Kangaroo Bay Hotel

Architectural Overview for TPC Hearing

9:30am, Tuesday 4th August 2026

2.1.9 – The extent to which parking is integrated into the built form

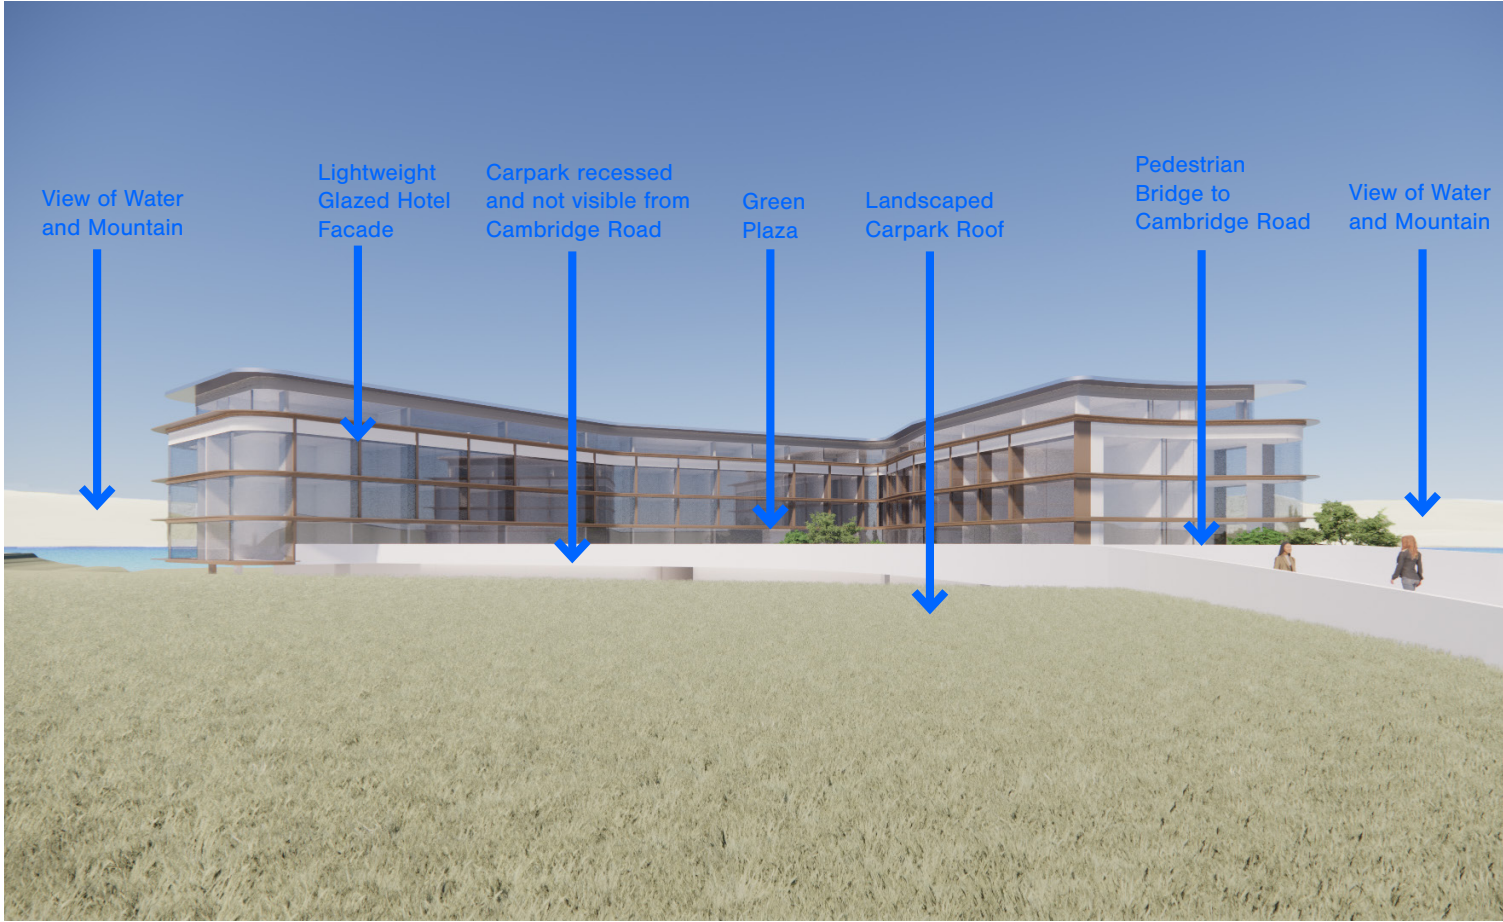
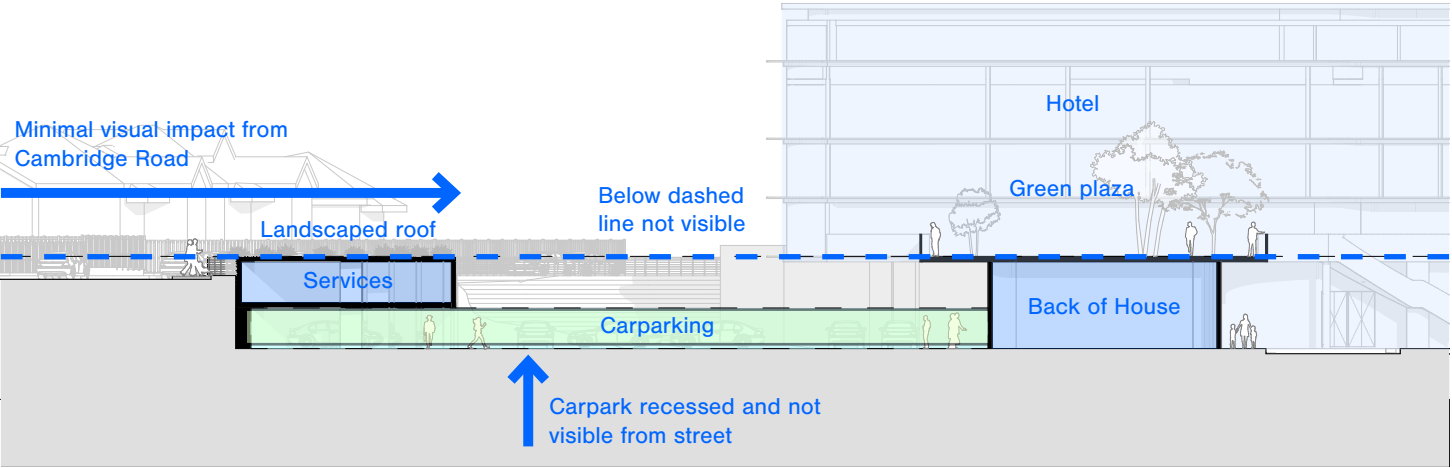
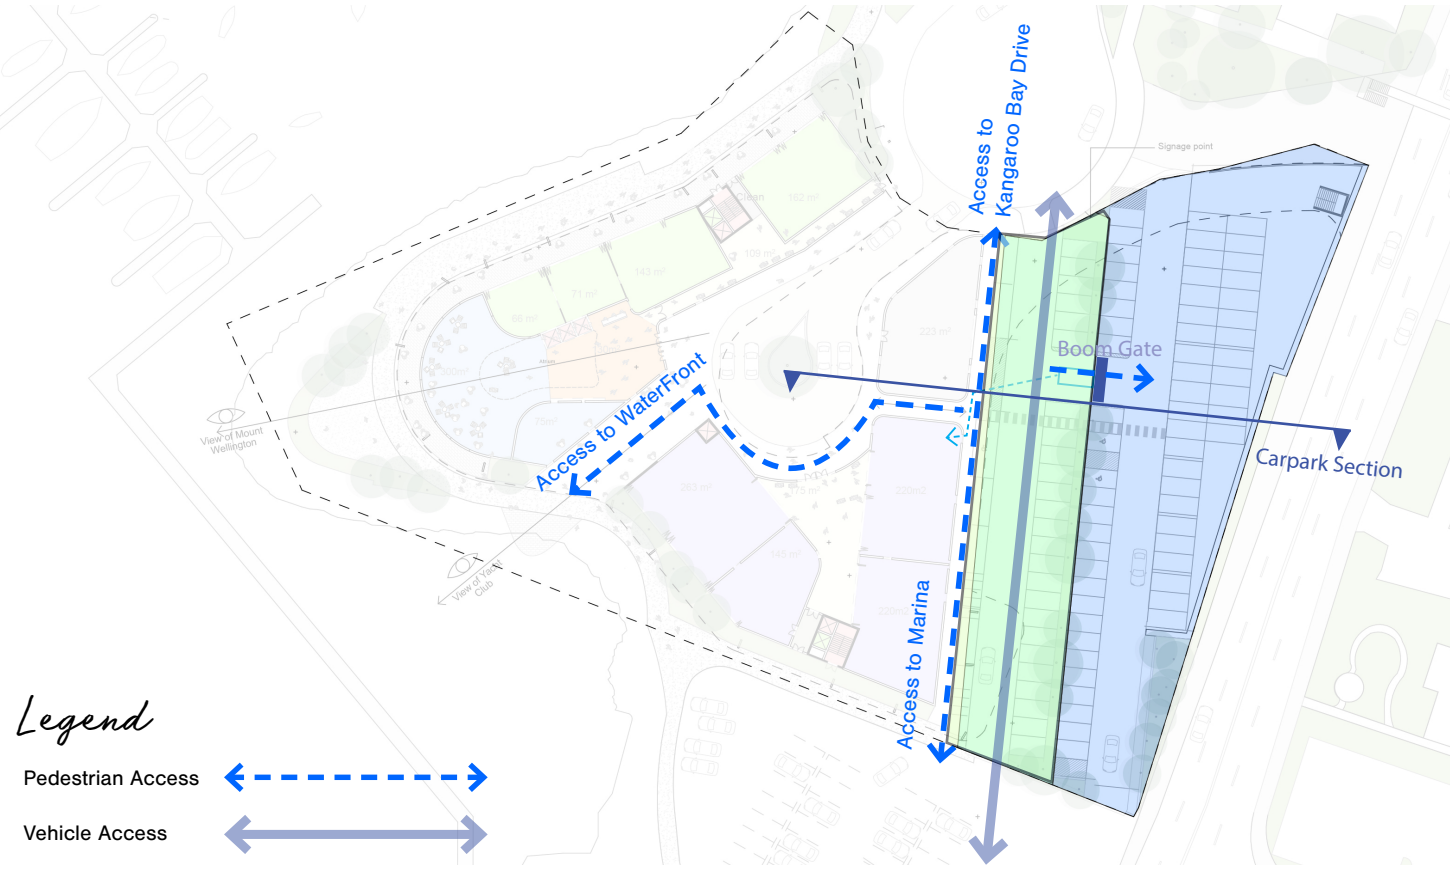
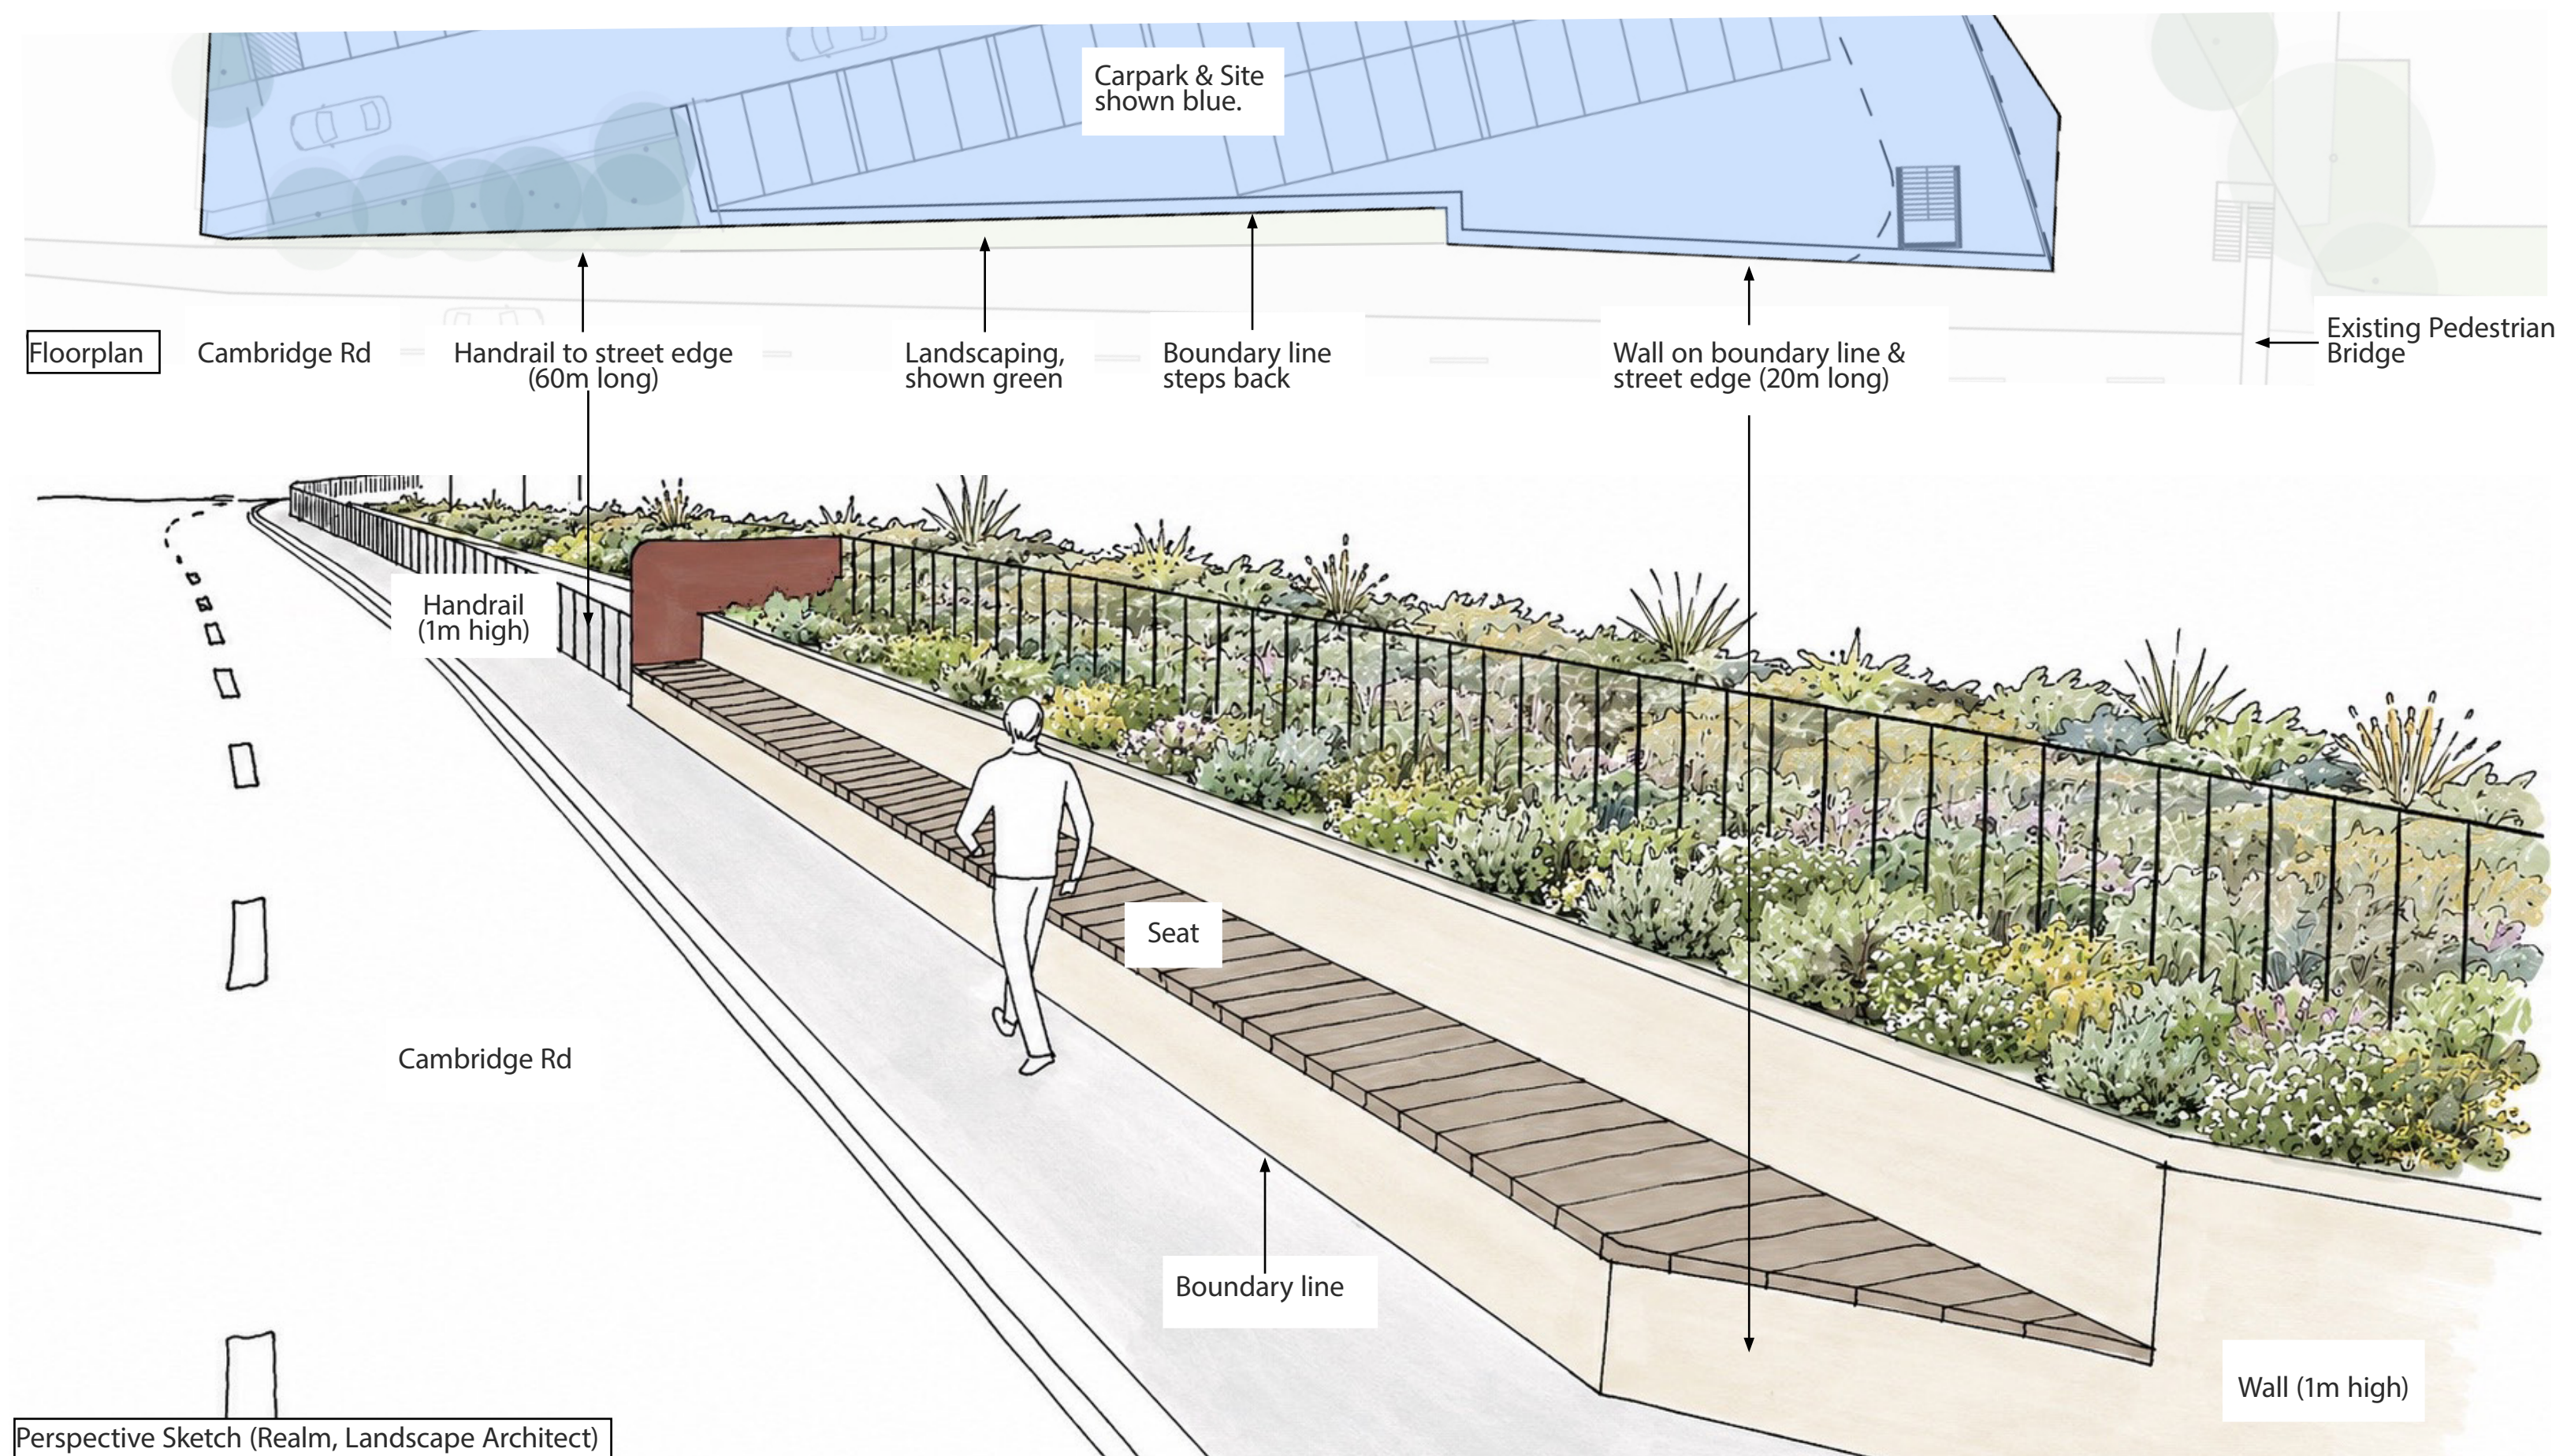
In response to Council's concerns regarding the car park wall interface with Cambridge Road, a public seat and setback handrail can be incorporated to provide a softer transition between the street and the car park.

Parking is fully integrated and concealed within the building envelope, with landscaped roof areas, setbacks and planting minimising visual impact from Cambridge Road while maintaining views and visual permeability to the waterfront.
